10th Ave Estates Functional Servicing Report

10th Ave Estates Functional Servicing Report

10th Avenue Estates
City of Owen Sound
Graham Design & Construction

City of Owen Sound Comments from Jacklyn lezzi on August 28th, 2024 and Greyfair Draft Plan (prepared by Gamsby and Mannerow Ltd. in 2006)

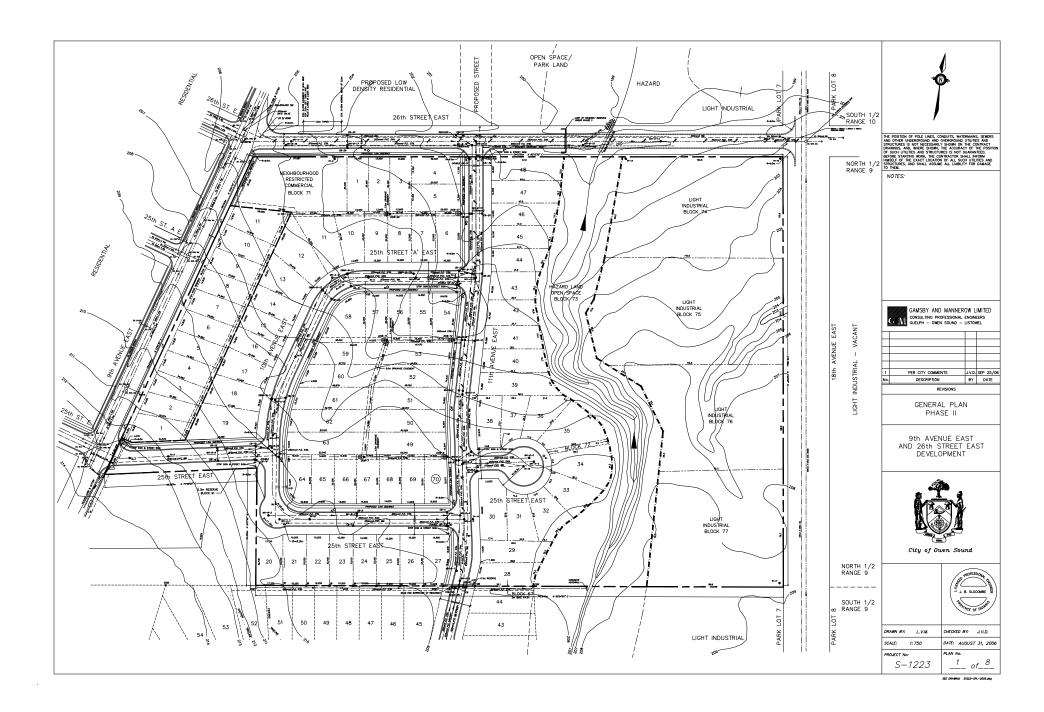
Off-site improvements to City watermain infrastructure will be required to obtain additional water flow to support the identified water demand of the proposed development (domestic and fire flow). The revised FSR does not address how and if the fire flow demand required by the development can be met and is therefore not sufficient for demonstrating conformity with the policies of the City's 2021 Official Plan, as noted above.

Furthermore, the development is proposing the removal of the 10th Avenue East extension through the property. As discussed during the pre-consultation process, policy 4.1.3.1 of the City's Official Plan requires that lands be developed in general conformity with the schematic road system plan illustrated on Schedule 'A1' – East Bluffs Planning Area of the OP. For local roads, the road system plan may be considered illustrative only and changes to the location and configuration of such streets shall be permitted without an Official Plan Amendment, provided that the planned street does not adversely impact the development ability of adjoining lands, or the general traffic flow system provided, and the layout is in accordance with proper design principles. A Transportation Impact Assessment (TIA) was identified as being required as part of a complete ZBA application. The Terms of Reference provided for the TIA acknowledges the linear north-south underground infrastructure corridor to the east of 9th Avenue East that would be provided with the extension of 10th Avenue and requires, among other matters, an analysis of the impacts on infrastructure redundancy in the proposed absence of this road connection.

As it relates to water servicing, the draft approved plan of subdivision for the Greyfair lands (attached and provided at the time of

pre-consultation) identifies the extension of the existing, 200 mm diameter PVC watermain at the termination of 10th Avenue East northerly through the subject property via 10th Avenue and looping through the internal roads of the subdivision to connect to the existing, 200 mm diameter ductile iron watermain on 9th Avenue East at 25th Street East in the Municipal Pressure Zone, to provide for a looping watermain. The removal of the 10th Avenue East extension will remove the potential for a looping watermain and rationale for the water supply for Greyfair is required in consideration of this loss (i.e., there may need to be multiple taps of the watermain to loop and provide waterflow, which may have been offset by the connection through the subject property via 10th Ave). Additionally, it merits note that a looping

watermain as it's anticipated by the draft plan, would provide for additional water flow which, based on the conclusions of the revised FSR, is required for the subject development.
